71-9204

Subject: Response to Request for Additional Information – Docket No. 71-9204

A. Revised response to RAI comment 4.10.2 A-4

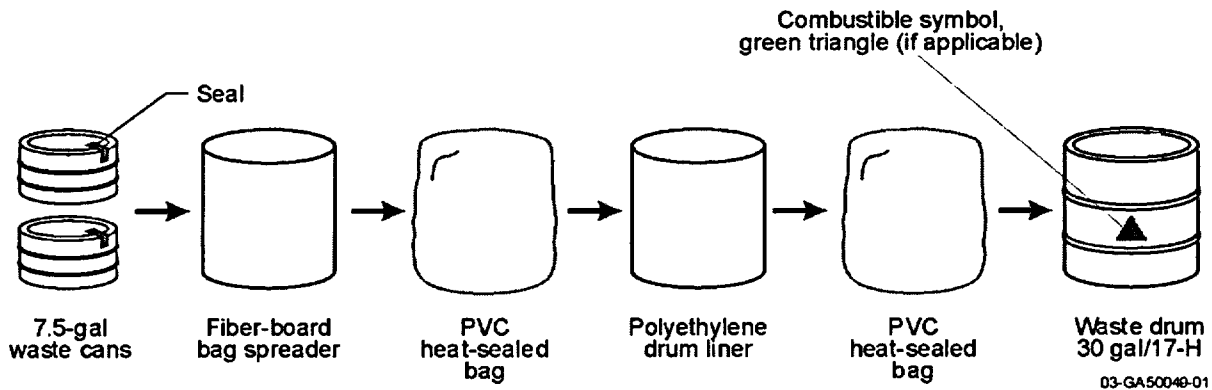
The 7.5-gallon waste cans are not considered to be sealed containers because holes were drilled in the sides of the cans to allow a cable to be attached to enable the waste cans to be moved by robotic arm (Reference 12.1, Appendix 4.10.2.5). The fiberboard bag spreader, which is situated between the waste cans and the PVC bag, is open on top and serves only as a means of support for the innermost PVC bag as the waste cans are placed in the waste drum. Neither the waste cans nor the fiberboard bag spreaders inside the innermost PVC bag are considered confinement layers. Hydrogen release rate from openings in the waste cans via gas

The waste packaging configuration figure and text clarifying the confinement layers will be added to Appendix 4.10.2.5.

Thirty-gallon and 55-gallon secondary containers may be used as payload containers in the CNS 10-160B cask. Secondary containers must be shored to prevent movement during accident conditions. The available volume of the cask cavity limits the number of payload containers that may be shipped at one time. Up to ten 30-gallon or 55-gallon drums of TRU waste may be packaged in the cask. Payload containers and any sealed container liners greater than four liters in volume used to package waste inside the containers must have at least one filter vent with a minimum allowable hydrogen diffusivity listed in Table 8.1. A rigid polyethylene liner, if present in a payload container, shall have an opening that is equivalent to or larger than a 0.3-inch diameter hole (or equivalent filter vent) before the container is transported in the CNS 10-160B. The typical waste packaging configuration is shown below.

The 7.5-gallon waste cans are not sealed containers because holes were drilled in the sides of the cans to allow a cable to be attached (Reference 12.1, Appendix 4.10.2.5). The fiberboard bag spreader, which is situated between the waste cans and the PVC bag, is open on top. Neither the waste cans nor the fiberboard bag spreader inside the innermost PVC bag are considered confinement layers.
